**From:** Rourke, Kristin  
**Sent:** Tuesday, November 27, 2012 12:36 PM  
**To:** Murray, Chris; Stoner, Frank  
**Subject:** November BAR - 1512 East Market Street

**Certificate of Appropriateness Application**

BAR 12-11-05  
1512 East Market Street  
Tax Map 56 Parcels 40.4 and 109  
Milestone Partners, Applicant/JABA Timberlake Place LLC, Owner  
Amended site and lighting plans, Side and rear elevations for buildings 1 and 3

**CITY OF CHARLOTTESVILLE  
BOARD OF ARCHITECTURAL REVIEW  
STAFF REPORT  
November 20, 2012**

L1

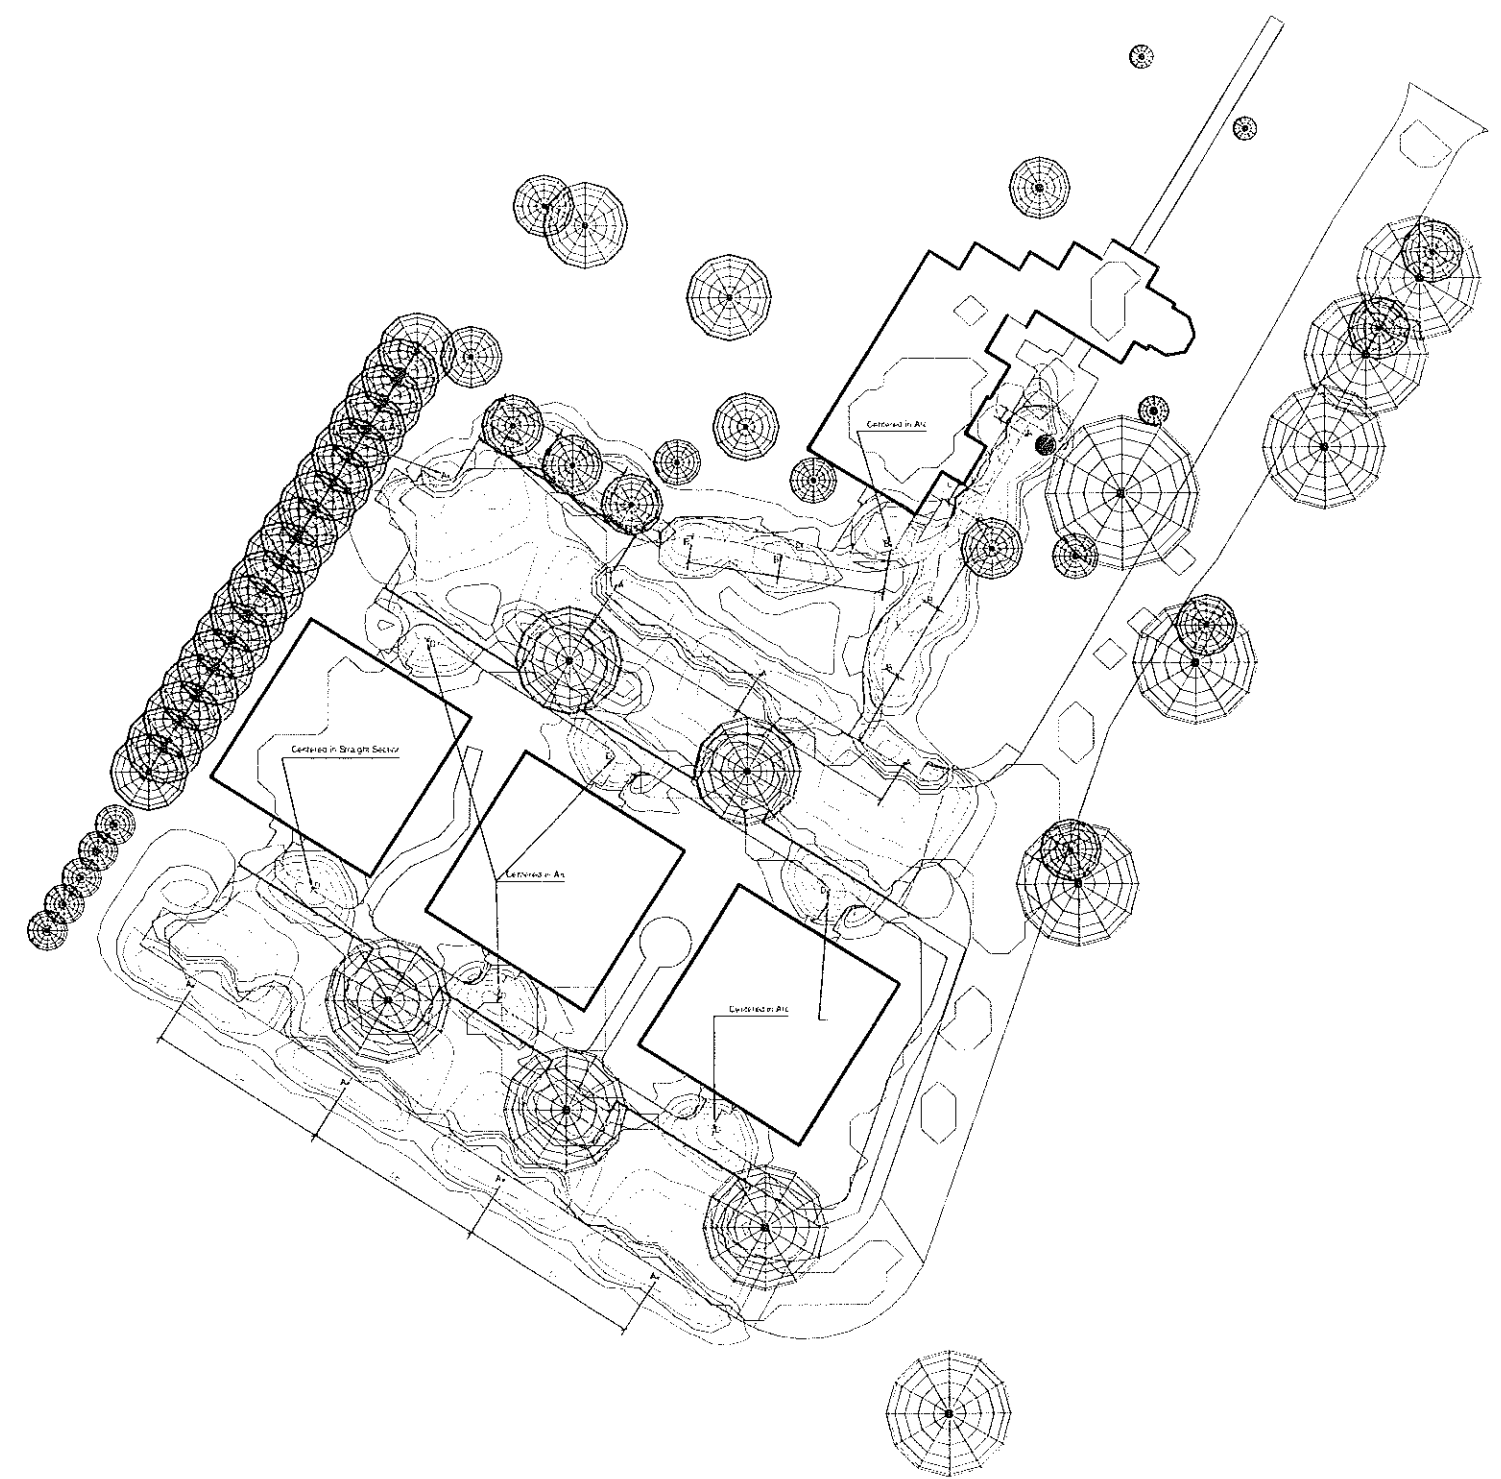
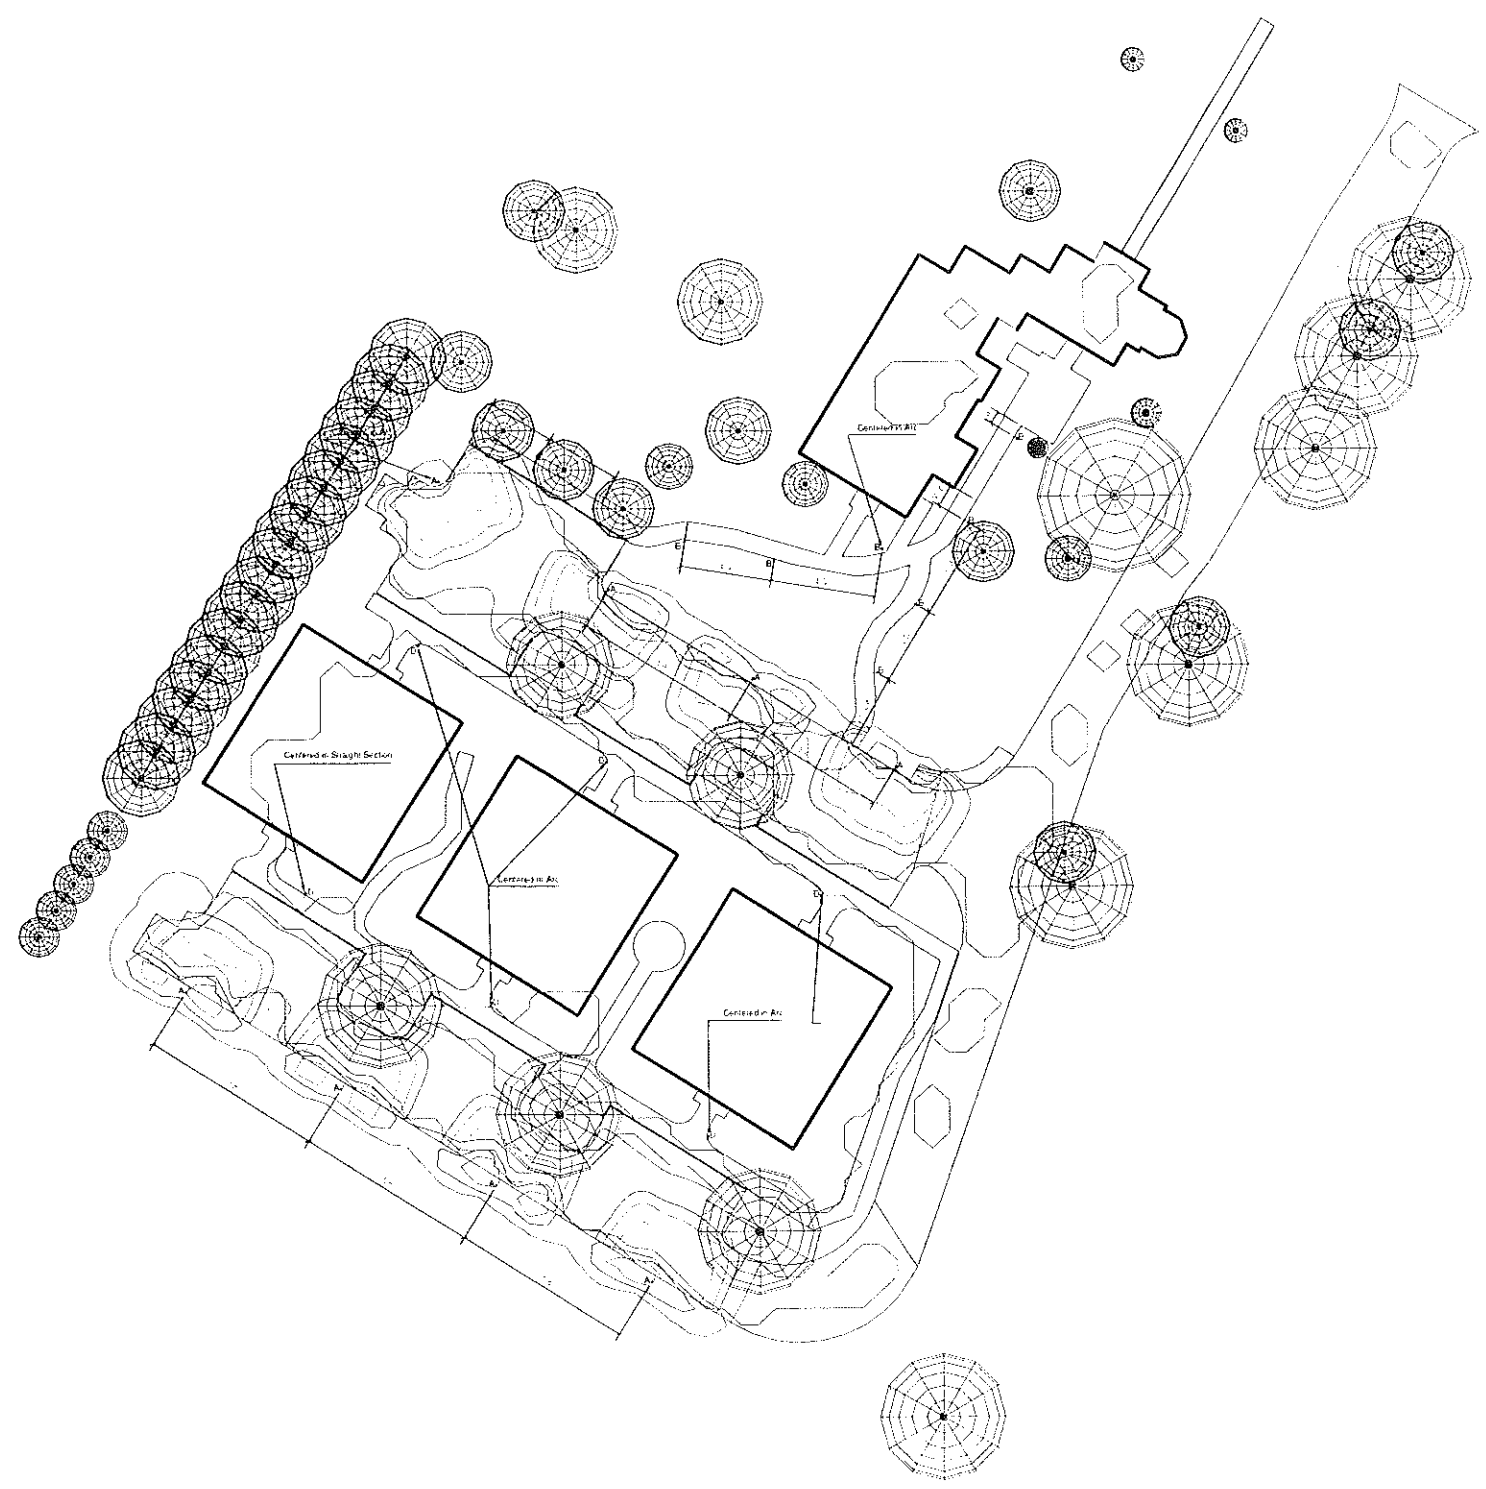
The lighting plan shows three types of fixtures: pole lights on a ten foot pole, and two heights of bollard lights. They are indicated by very small letters, A, B, and D on sheet L1. (The circles on that sheet are trees). The pole lights are located in the parking lots. The light levels of the pole lights will reduce by ½ when there is no activity. The pathway lights are motion sensor activated. The pole lights exceed 3000 lumens and will be dark sky compliant. The lighting plan was designed by Mark Schuyler.

Staff recommends approval as submitted. In addition to these changes, the applicant noted they have gone back to cementitious shingles rather than vinyl shingles.
